Date: 6 March 2000
 To: T10 Technical Committee
 From: Ralph O. Weber
 Subject: SAM-2 Models for Multiple Port Devices

The January working group discussed the target device model figures for devices with multiple ports in SAM-2 revision 12. This document reviews that discussion and provides the basis for further discussions.

Figure 1 — Current SAM-2 SMU target structure model

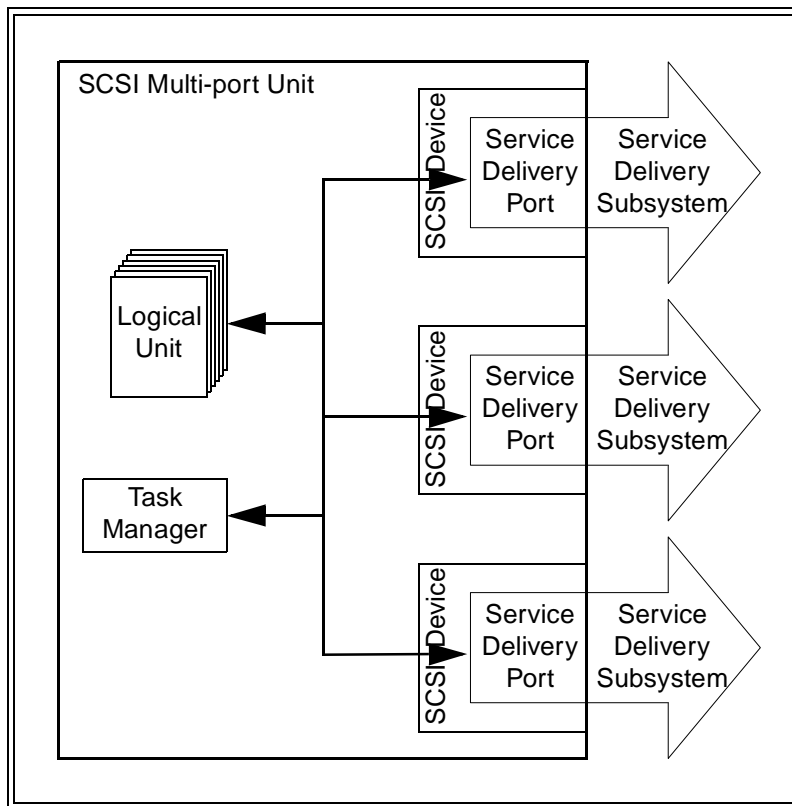
The broadly held concern from the January meeting is that this figure conflicts with other parts of SAM-2 that show the logical unit as part of the SCSI Device (see SAM-2 revision 12 figure 13, pdf page 45 in sam2r12.pdf). The boxes representing the SCSI Device should be drawn to include the logical units.

Figure 2 — SMU target structure model (with modified SCSI Device definition)

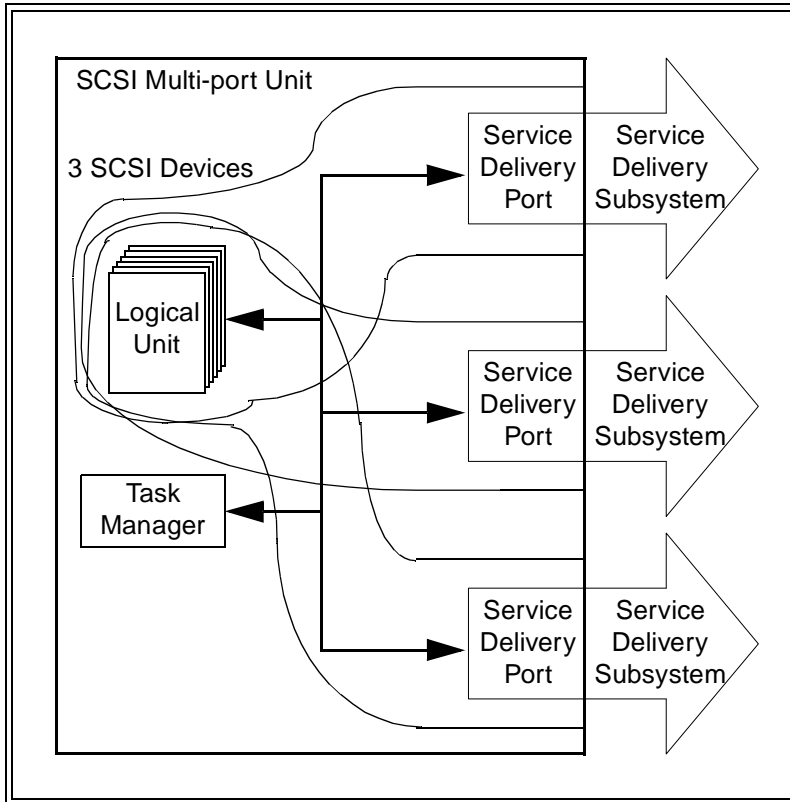
Figure 2 is figure 1 redrawn to have the SCSI Devices including the logical unit(s).

Figure 3 — SCSI Device Model for Multiple Port Devices

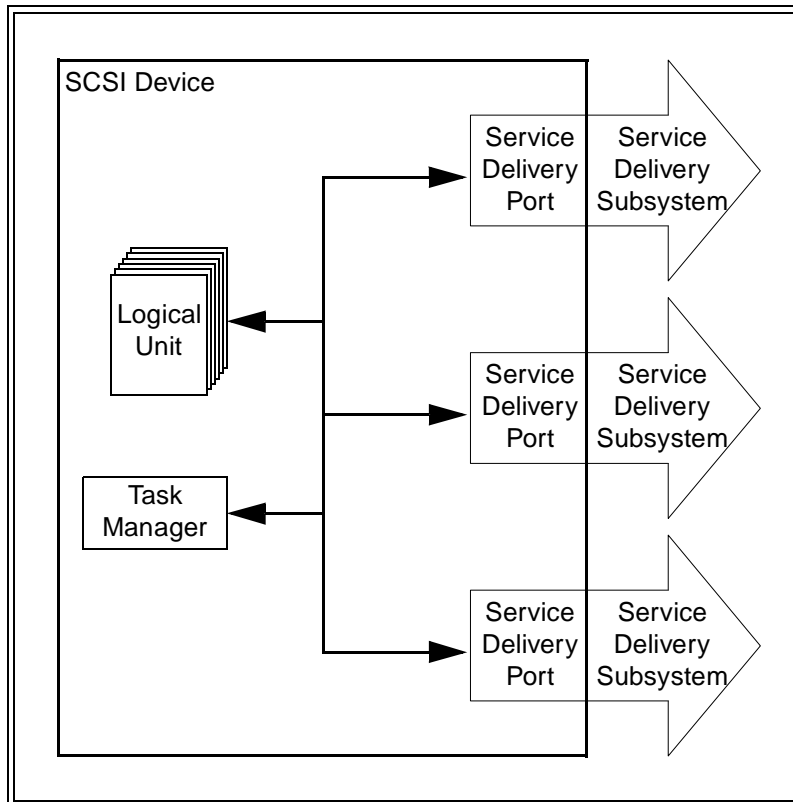
A more pervasive change (that has the interesting effect of making the figure simpler) would be to use the name "SCSI Device" in place of the name "SCSI Multi-port Unit".

Figure 3 shows the model with "SCSI Device" in the place of the name "SCSI Multi-port Unit".

Figure 4 — SMU target structure model (with different LU views at different ports)

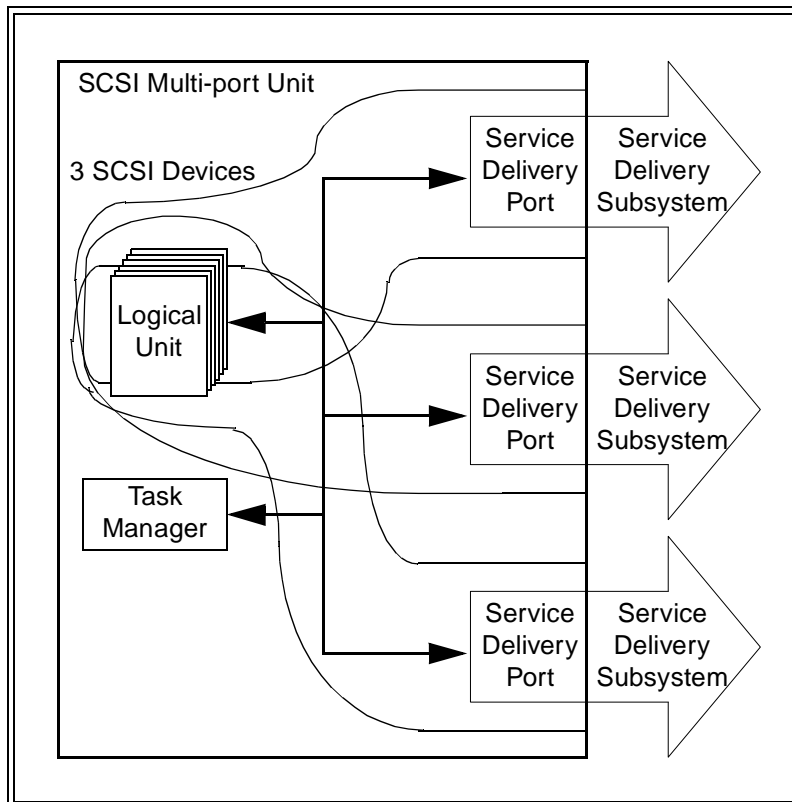
Another concern with the model for devices multiple ports relates to whether different views of the logical units can be accessible through different ports. As figure 4 shows, minor changes are required in figure 2 to accommodate the "different logical units" concept.
